Subject: FW: [EXTERNAL]FW: Lynwood HS Vulcan
From: Roxanne Holt <Roxanne.Holt@vulcanhart.com>
Date: 4/20/2022, 10:07 AM
To: "ddb@davidbethel.com" <ddb@davidbethel.com>

To: Moore, Lyman <Lyman@klh.com>
Cc: Jeremy Carver <jcarver@ricca.com>; Danielle Kunkel <dkunkel@ricca.com>
Subject: Lynwood HS Vulcan

VH-LYNWD : LYNWOOD HIGH SCHOOL
Created 04-21-2022 : 08:25:21.am

22079-QF400-1-Foodservice Equipment Plan TW 2022_04_19.pdf

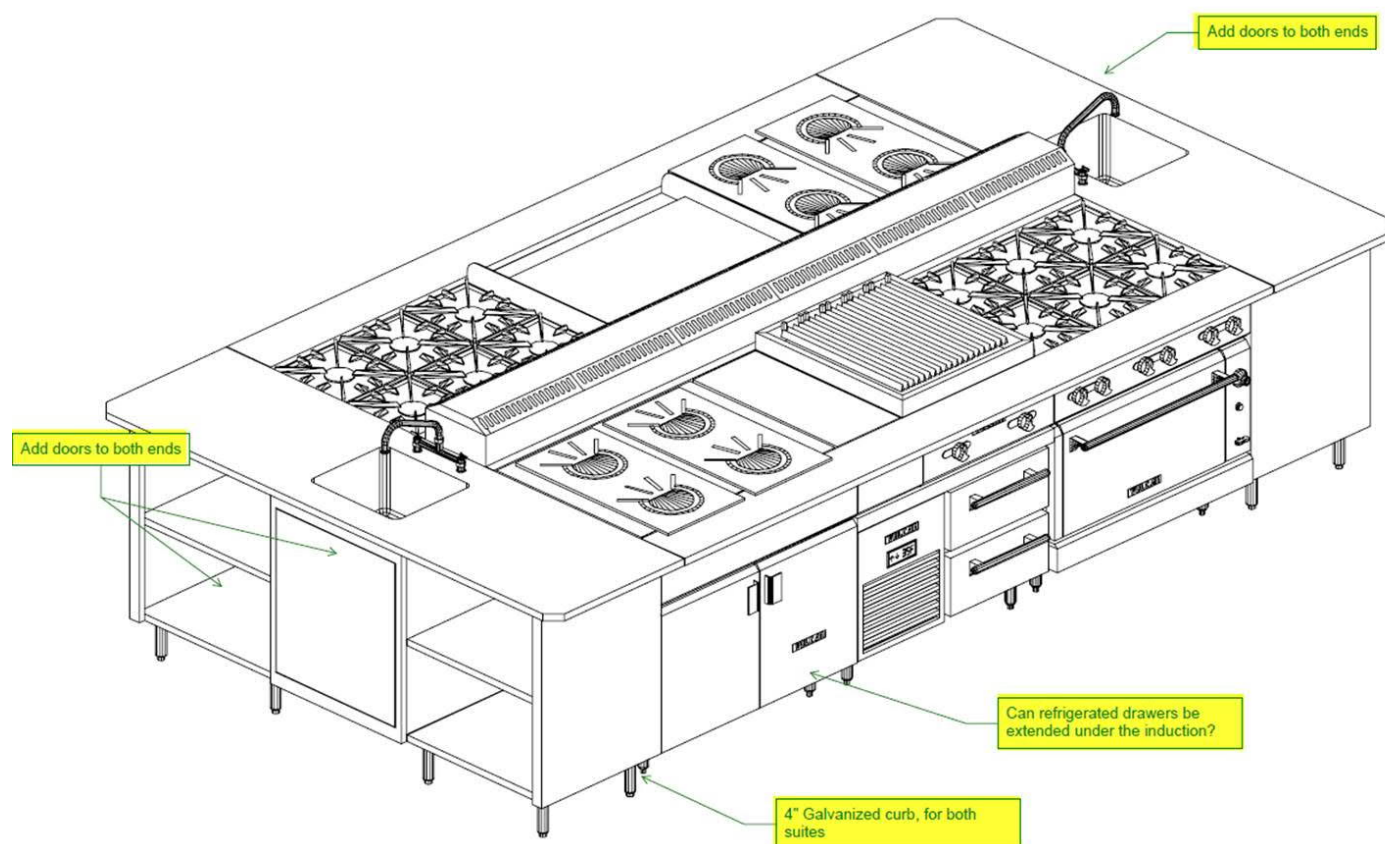
We will be using cooking suites after all. See attached mark ups, our intention for the purple cabinet base is to get around a 36" section with cabinets for pot and pan storage, then a 36" section with stacked drawers for utensil storage.

The induction will likely be a Cooktek style countertop unit on top of a refrigerated base.
